NINE MILE POINT NUCLEAR STATION, UNIT NO. 1

Amendment No. 47  
License No. DPR-63

ATTACHMENT TO LICENSE AMENDMENT NO. 47

The amendment revises the Technical Specifications to modify the Maximum Average Planar Linear Heat Generation Rate.

Figure 3.1.7a MAXIMUM ALLOWABLE AVERAGE PLANAR LHGR APPLICABLE TO 8DB250 FUEL AS DESCRIBED IN REFERENCE 8.

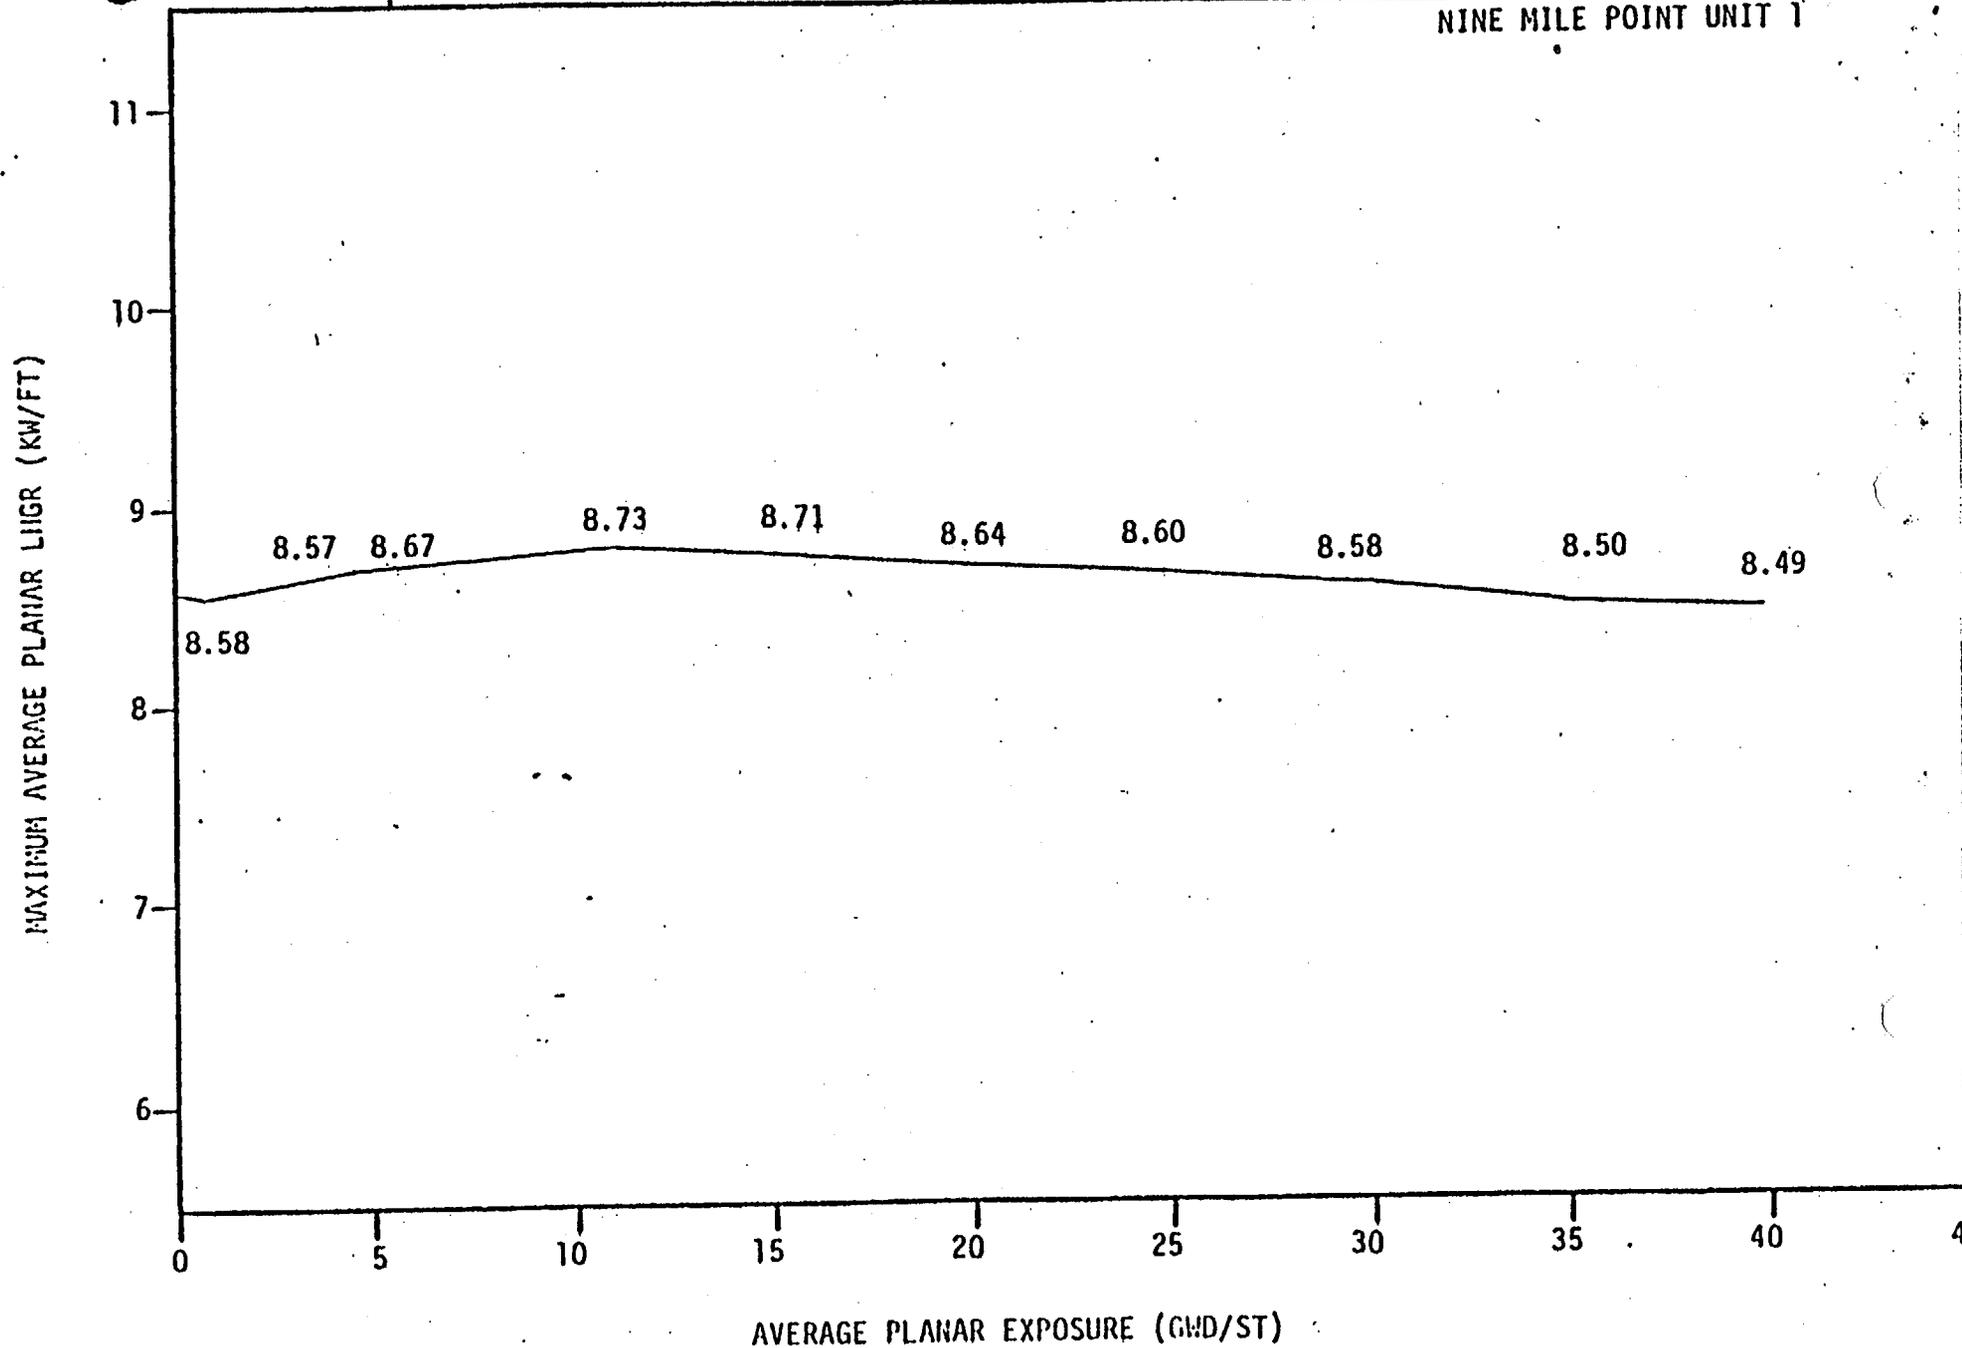
In References 1 and 2, General Electric Company requested that credit for calculated peak cladding temperature margin as well as credit for recently approved, but unapplied, ECCS evaluation model changes be used to offset any operating penalties due to high burnup fission gas release. This proposal was found acceptable (Ref. 3) provided the generic analysis was found to be applicable to each plant citing the GE position. In Attachment B of Reference 4 Niagara Mohawk Power Corporation stated that the generic analysis is applicable to Nine Mile Point Unit 1. On this basis we find the proposed Technical Specification changes (MAPLHGR limits) given in Attachment A of Reference 4 acceptable.
